**MINUTES**  
**WORCESTER TOWNSHIP PLANNING COMMISSION**  
**WORCESTER TOWNSHIP COMMUNITY HALL**  
**1031 VALLEY FORGE ROAD, WORCESTER, PA 19490**  
**THURSDAY, October 24, 2024 - 7:00 PM**

**Subject: C. Bradford & Sandra B. Smith – Minor Subdivision Plan  
3120 Fisher Road, Worcester Township**

**RECORD PLAN (1 OF 1)  
MINOR SUBDIVISION PLAN**

Reference: 3120 Fisher Rd.  
Parcel No. 67-00-01190-00-3  
Bradford Minor Subdivision Plan Review  
Worcester Twp. LD 2024-02

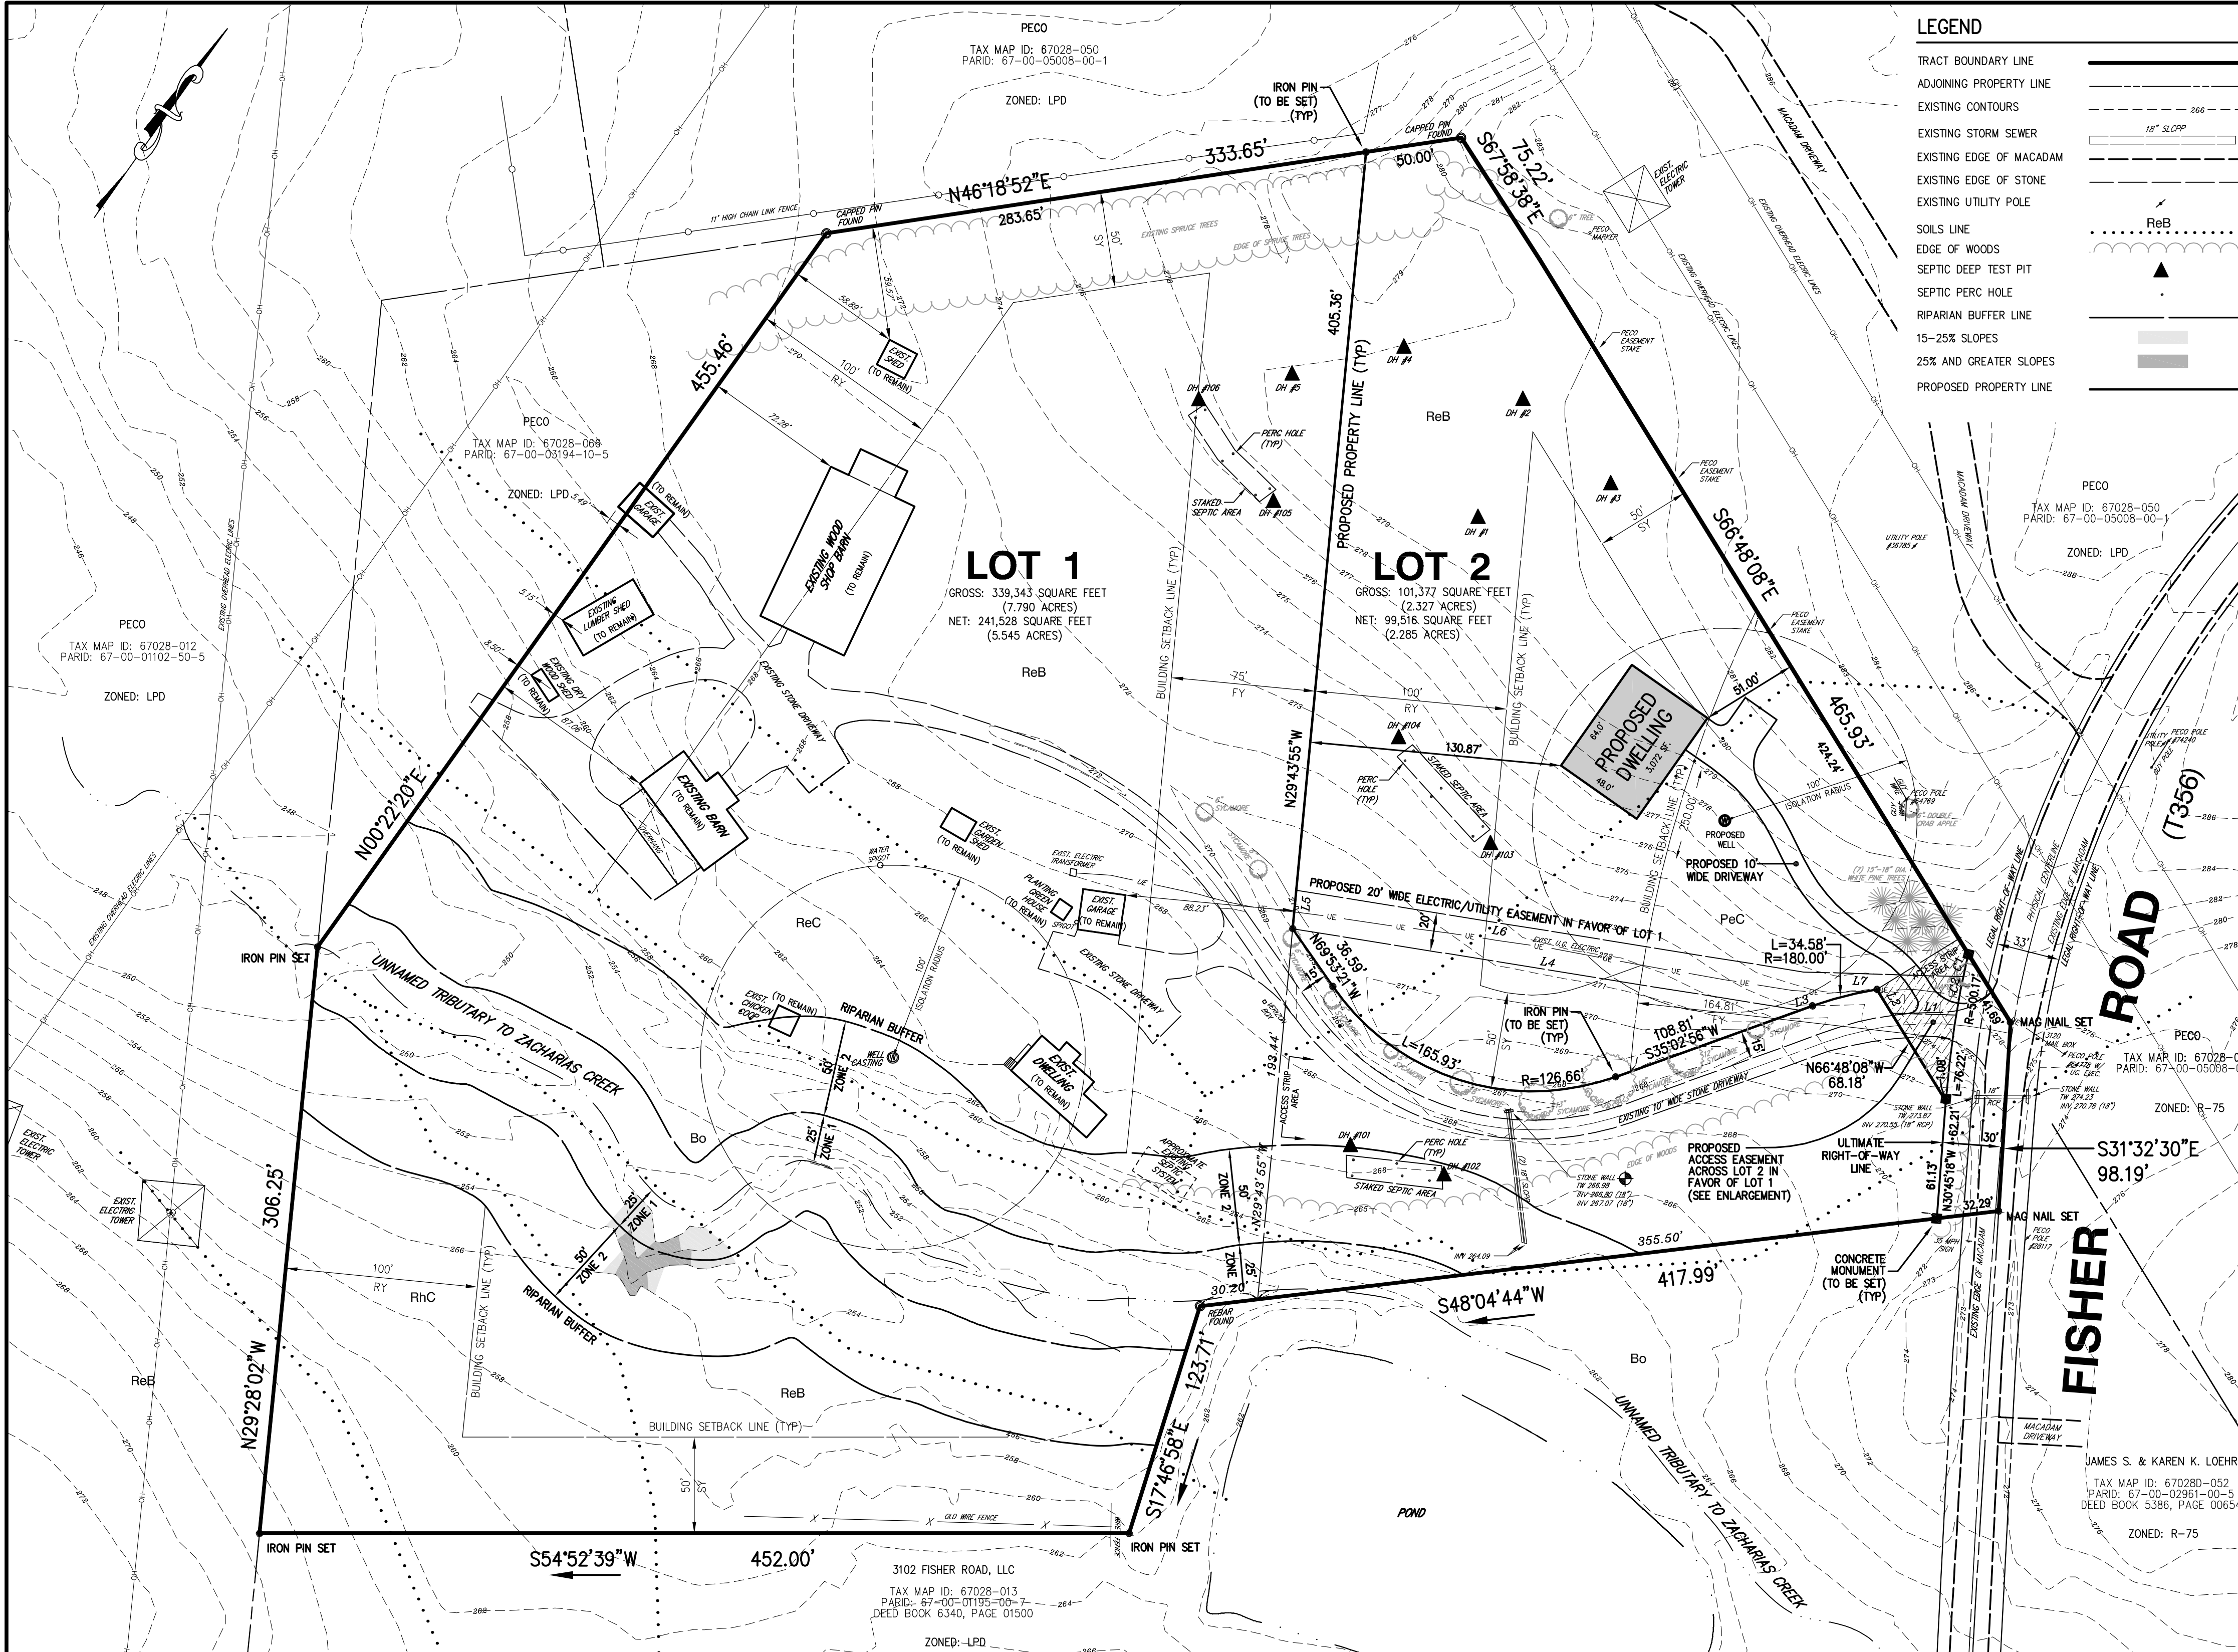
1. The existing use of Lot 1, single-family detached dwelling, is permitted. However, we note that accessory building coverage is over seven times that of the principal dwelling area footprint and defer to the Township Zoning Officer to confirm that all accessory buildings as shown on the plan were previously approved by the Township as accessory structures. It is our understanding that a woodworking business may be present on the site, but this is not indicated on the plans as a home occupation or similar use. However, the building areas dedicated to the use appear to exceed ordinance limitations for a home occupation. (150-110.22.A.1, 150-110.22.C, 150-177.A and 150-201)

2. The westernmost garage (to remain) located north of the lumber shed on Lot 1 is shown to partially encroach the lands of PECO, Parcel No. 67-00-03194-10-5. We recommend an easement be secured from PECO for this encroachment if the garage will not be relocated or demolished as part of this application.

3. Multiple structures on Lot 1 are located within the rear yard setback. The Township Zoning Officer should confirm if these are non-conforming as footnote [1] of the Zoning Data table indicates. (150-177.A.2)

4. The proposed use of Lot 2, single-family dwelling, is permitted by-right in the LPD district if development is in accordance with the regulations of the AGR Agricultural District. General Note 11 indicates that the intent of this plan is "for subdivision only"; therefore, the dwelling proposed on Lot 2 is conceptual in nature but does demonstrate that a dwelling satisfying the dimensional and parking requirements of the AGR district could potentially be constructed on the subdivided lot. (150-110.22.A.1 and 150-12 through 150-16)

1. The paved cartway width(s) of Fisher Road must be dimensioned on the plan. (130-35.1.A.3.c.1)
2. The street classification of Fisher Road must be noted on the plan. (130-35.1.A.3.c.1)

3. Whenever practical, the sidelines of a lot shall be at right angles or radial to the right-of-way line. We note that a 50-ft. minimum 'leg' must be provided for Lot 2. We request that the curved lot line be reconfigured to eliminate the curved portion of the lot line to make Lot 2 more a regular shaped lot.

4. It is our understanding that the existing driveway serving Lot 1 is of stone material. We recommend the driveway apron between the existing cartway edge and ultimate right-of-way line be paved with asphalt material. A typical section detail for any proposed paving must be added to the plan. (130-17.B.3)

5. We calculate that a minimum of four street trees are required, or five if the existing driveway is not excluded from the calculation. The trees must be spaced 25 feet on-center and located at least five feet behind the right-of-way line. Due to the presence of existing White Pine trees at the frontage, a lesser quantity may be sufficient if these plantings are deemed to be suitable street trees. The plan does not propose any new street trees. (130-28.G.4)

6. Lot 2 must provide a softening buffer along its side and rear lot lines which abut the lands of PECO. The buffer shall consist of a minimum of one evergreen tree for each 35 linear feet; one ornamental or shade tree for each 50 linear feet; and one shrub for each 10 linear feet of property line. Informal groupings of more closely spaced plants which reflect the natural character of the site are encouraged. Existing vegetation of appropriate species and quantities on the property can be considered in the fulfillment of these

7. The setback dimension of the staked septic area on Lot 1 must be added to the plan. The on-lot sewage disposal area may not be located in a required front yard nor 10 to 30 feet from a property line. The current location may not satisfy one or both conditions. (130-26.B.2.c)

8. A minimum of three deciduous or evergreen trees must be proposed to be planted on Lot 2, unless an equivalent number of existing trees are already on the lot. We note several evergreens are present on Lot 2. (130-28.9.A)

9. The future well on proposed Lot 2 must be constructed in accordance with PADEP and Township requirements. (130-31.C)
10. Areas of steep slopes on the lot must be defined. If none are present, this condition should be stated as a general plan note. (130-32.1)

11. The applicant should confirm that there are no deed restrictions or covenants which would otherwise prohibit the subdivision of the lot as proposed. (130-34.J.2.h)

12. The applicant is seeking waivers from the following three sections of the Worcester Township SLDO:
  - a. Section 130-16.C.2 to not require the minimum width of paving for the roadway classification.

We note that lot frontage is approximately 138 feet at the ultimate right-of-way line. Due to the existing use of the lot to the north (PECO) and environmental features on the lot to the south (unnamed tributary to Zacharias Creek), we are not opposed to the waiver request for sidewalks; however, should the Township ever desire a trail system along Fisher Road, this may be the only opportunity to provide such infrastructure along this frontage.

As the existing driveway access will be maintained and only be modified to accommodate interconnection with a future access driveway serving a dwelling on Lot 2, we take no exception to this waiver request. However, if the Township deems sidewalk necessary and does not grant the waiver described in item 'b' above, we believe that the installation of curbing would also be appropriate in conjunction with such sidewalk.

1. The application must be reviewed by the Montgomery County Planning Commission.
2. The applicant should provide evidence of the feasibility of on-lot sewer service for Lot 2 per PA Title 25 Chapter 73. A primary disposal area and secondary reserve area should be conceptually sized and located on the plan. Only one septic area is shown on Lot 2 at this time. Additionally, a septic area is proposed on Lot 1, but approximately 30 feet from the rear of Lot 2. The applicant must clarify which lot each area is intended to serve. Approval of the PADEP and Montgomery County Health Department will be required for any future system to be installed.

3. Legal descriptions, to be reviewed under separate cover following plan approval, must be supplied for the following:
  - a. The 20-ft.-wide electric/utility service easement through Lot 2, in favor of Lot 1.

Due to the minor nature of this proposal, we take no exception to this request.
